These amendments revise the Technical Specifications to specify new power distribution limits for base load and radial burndown operation.

ATTACHMENT TO LICENSE AMENDMENTS

SAFETY EVALUATION BY THE OFFICE OF NUCLEAR REACTOR REGULATION
RELATED TO AMENDMENT NO. 80 TO FACILITY OPERATING LICENSE NO. DPR-31
AND AMENDMENT NO. 74 TO FACILITY OPERATING LICENSE NO. DPR-41

FLORIDA POWER AND LIGHT COMPANY
TURKEY POINT PLANT UNIT NOS. 3 AND 4

HOT CHANNEL FACTOR
NORMALIZED OPERATING ENVELOPE

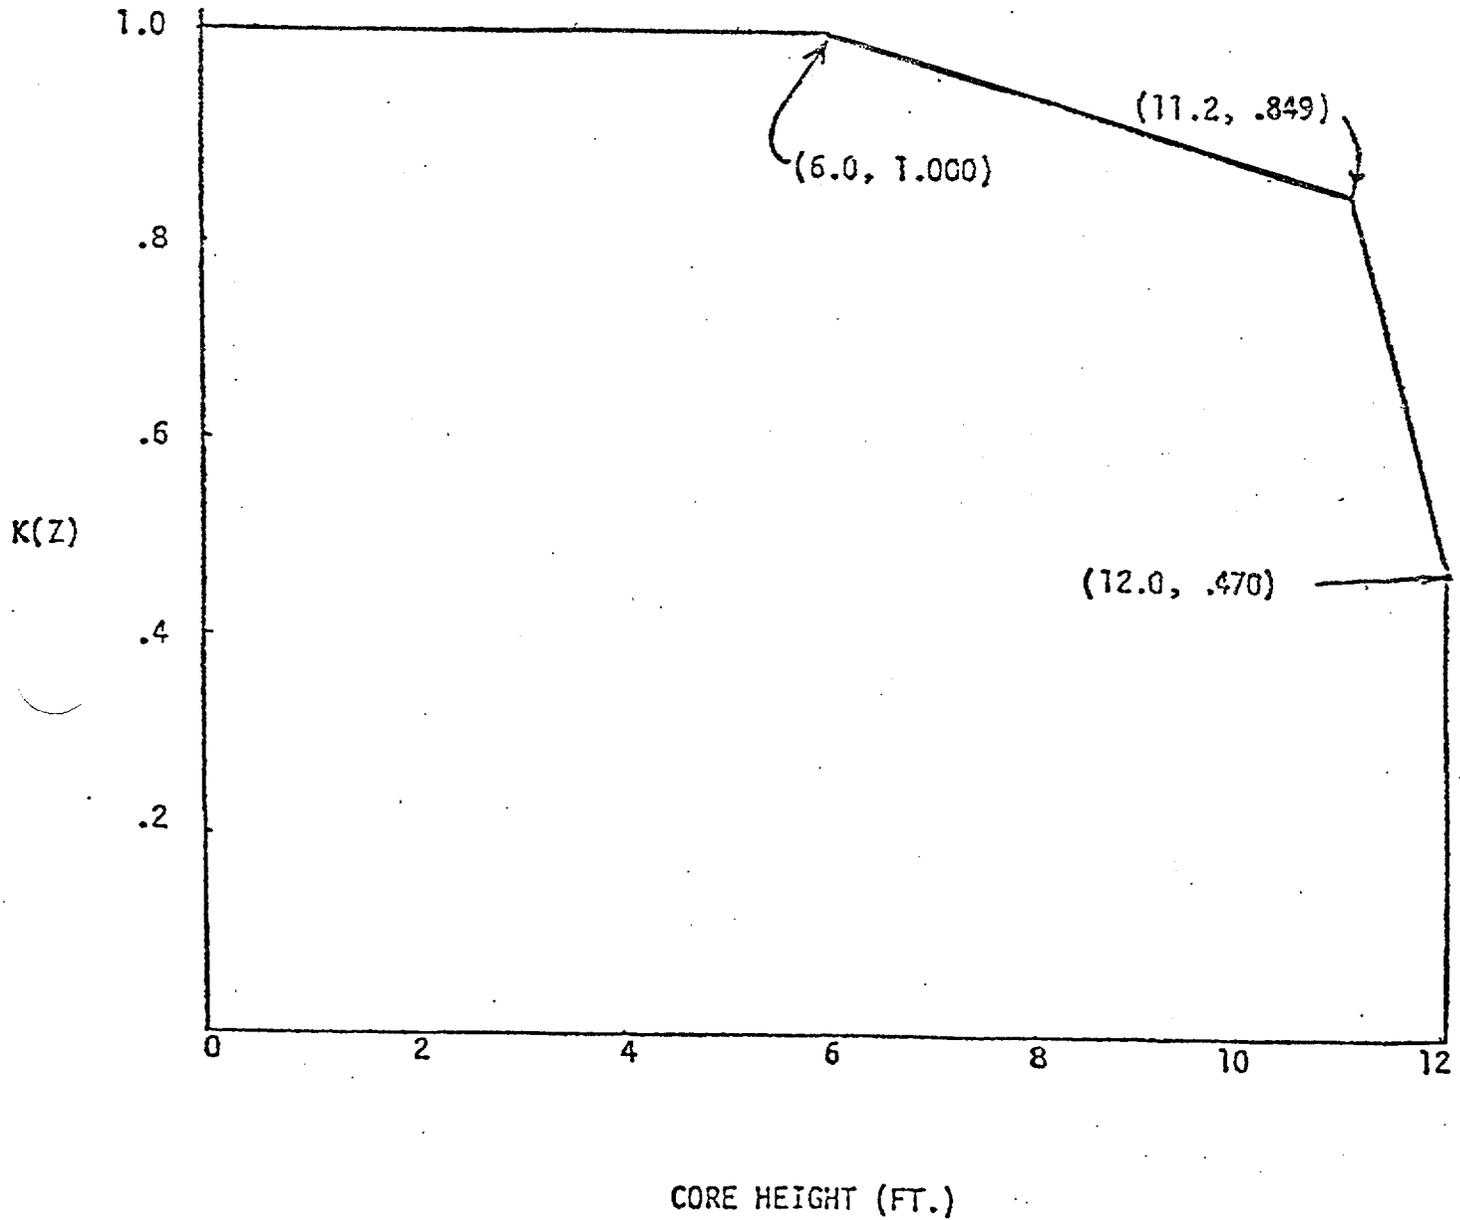
Where P is the fraction of rated power at which the core is operating; K(Z) is the function given in Figure 3.2-3; Z is the core height location of F_Q . $[F_Q]_L$ and K(Z) are dependent on the steam generator tube plugging level as follows:

Plugging level	$[F_Q]_L$	Figure Number for K(Z)
$\leq 28\%$	2.125	3.2-3

1. The axial power distribution shall be measured by MIDS when the thermal power is in excess of P_T such that the limit of $[F_0]_L/P$ times Figure 3.2-3 is not exceeded. $F_j(Z)$ is the normalized axial power distribution from thimble j at core elevation (Z).

(for $\leq 28\%$ steam generator tube plugging and $[F_0]_L = 2.125$)
